UNITED STATES PATENT AND TRADEMARK OFFICE

APPLICATION NO.	FILING DATE	FIRST NAMED INVENTOR	ATTORNEY DOCKET NO.	CONFIRMATION NO.
10/709,989	06/11/2004	Yui-Shin Fran	12960-US-PA	3988
31561	7590	04/05/2006	EXAMINER	
JIANQ CHYUN INTELLECTUAL PROPERTY OFFICE 7 FLOOR-1, NO. 100 ROOSEVELT ROAD, SECTION 2 TAIPEI, 100 TAIWAN			WON, BUMSUK	
			ART UNIT	PAPER NUMBER
			2879

Office Action Summary

DETAILED ACTION

Section view of figure 8A (Nishiyama)

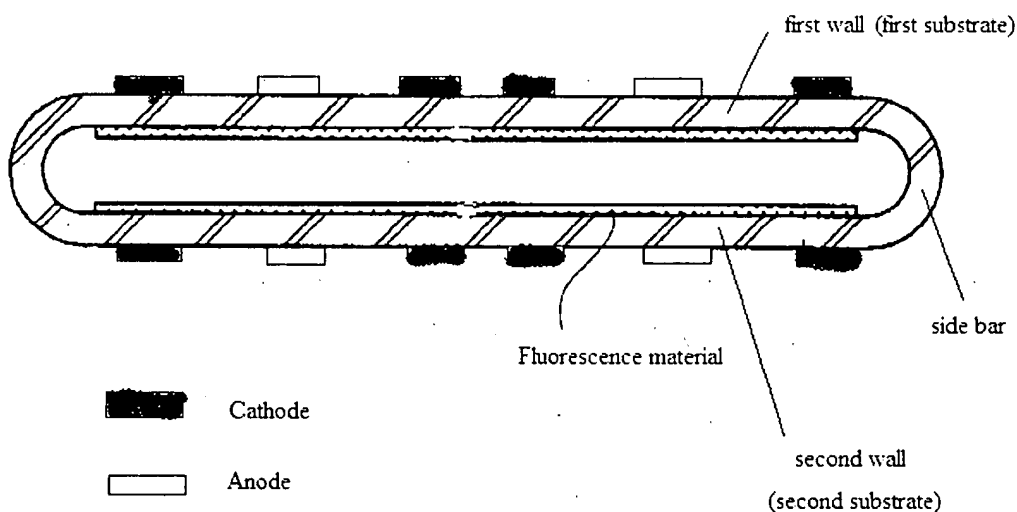
Regarding claim 1, Nishiyama discloses a cold cathode fluorescent lamp (figure 8A), comprising: a cavity (35), comprising a first inner wall (top portion) and a second inner wall (bottom portion) disposed opposite to the first inner wall; a fluorescence material (35q) disposed over the first and the second inner wall; a discharge gas (column 6, lines 11-14) disposed inside the cavity; a first electrode pairs (35c and 35d, top part) disposed over an outer wall of the cavity, wherein each of the first electrode pairs comprises a first anode (top part of 35c) and a first cathode (top part of 35d); and a second electrode pairs (35c and 35d, bottom part) disposed over an outer wall of the cavity, wherein each of the second electrode pairs comprises a second anode (bottom part of 35c) and a second cathode (bottom part of 35d) (see figure *Section view of figure 8A (Nishiyama)* for more detail).

Regarding claim 2, Nishiyama discloses the cavity (35) comprises: a first substrate (top portion); a second substrate (bottom portion) disposed over the first substrate; and a side bar (both right and left end portion) disposed between the first substrate and the second substrate, and the side bar is connected to an edge of the first substrate and an edge of the second substrate (see figure *Section view of figure 8A (Nishiyama)* for more detail).

Regarding claim 3, Nishiyama discloses the first electrode pairs (figures 6A and 8A, 35c, 35d, top part) are disposed over the first substrate (top portion of 35), and the second electrode pairs (figures 6A and 8A, 35c, 35d, bottom part) are

disposed over the second substrate (bottom portion of 35) (see figure *Section view of figure 8A (Nishiyama)* for more detail).

Regarding claims 6 and 7, Nishiyama discloses anodes (figure 8A, 35c) and cathodes (35d) being arranged in a sequence in an order of anode, cathode, cathode, anode (middle 4 electrodes meets the claimed sequence) (see figure *Section view of figure 8A (Nishiyama)* for more detail).
